Ferrari North America

Date: January 3, 2012
 Bulletin #: 1961
 Campaign #: 357
 Supersedes:
 Section:

Model Type: 458 Challenge
Model Year: All Models
Subject: Supplementary hydraulic fluid pipe fastener bracket

Fluid pipe bracket kit Part No. 70002291, consisting of (Fig. 1):

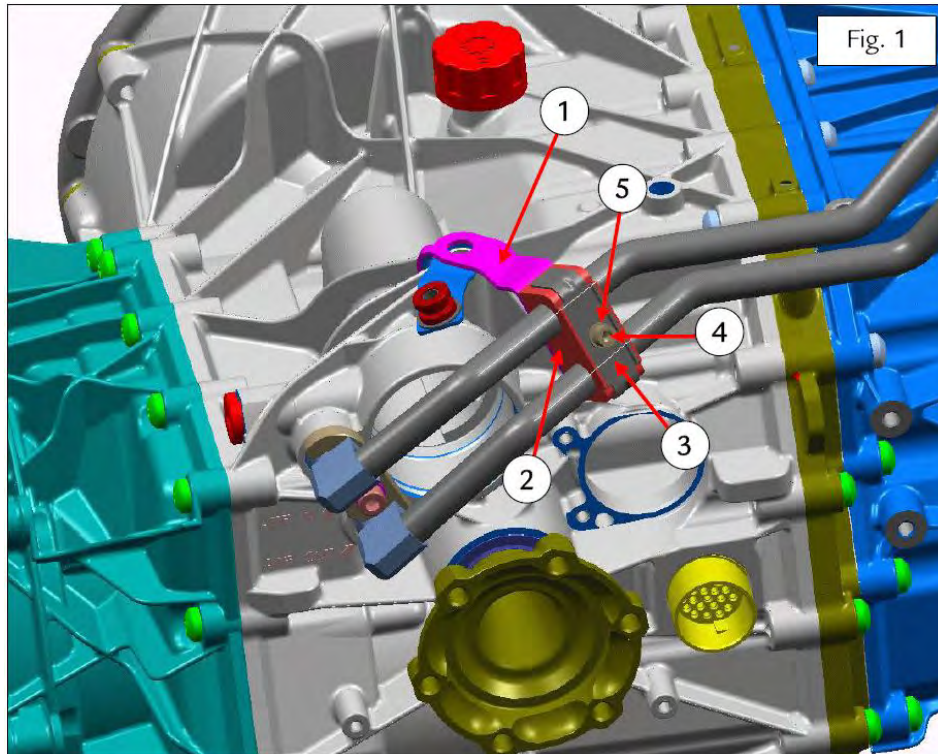
As an improvement to product reliability, it is necessary to fit the aforementioned bracket to vehicles from Assembly No. 95365 to Assembly No. 99865 as described in the following procedure. This bracket improves the fastening integrity of the hydraulic clutch fluid pipes.

- Clutch fluid pipe fastener bracket, Part No. 276819, Qty 1 (1)
- Pillory block, Part No. 243396, Qty 1 (2)
- Pillory block plate, Part No. 243398, Qty 1 (3)
- TCE M6x45 Screw, Part No. 11568224, Qty 1 (4)
- Bush, Part No. 243399, Qty 2 (5)

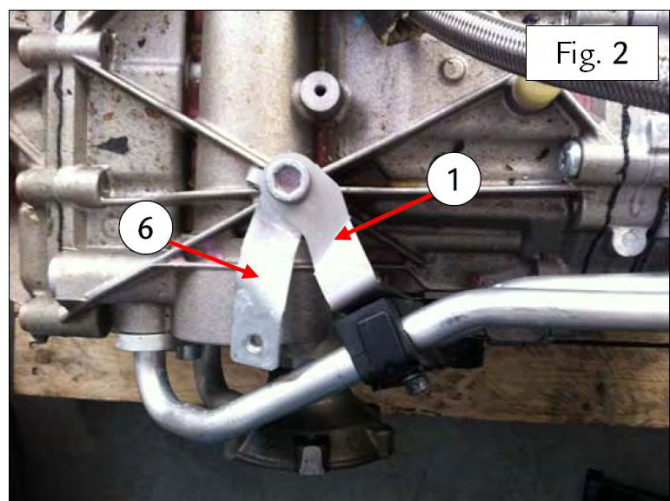
The bracket part No. 276819 (1) must be fitted over the heat shield fastener bracket (6) – Fig. 2.
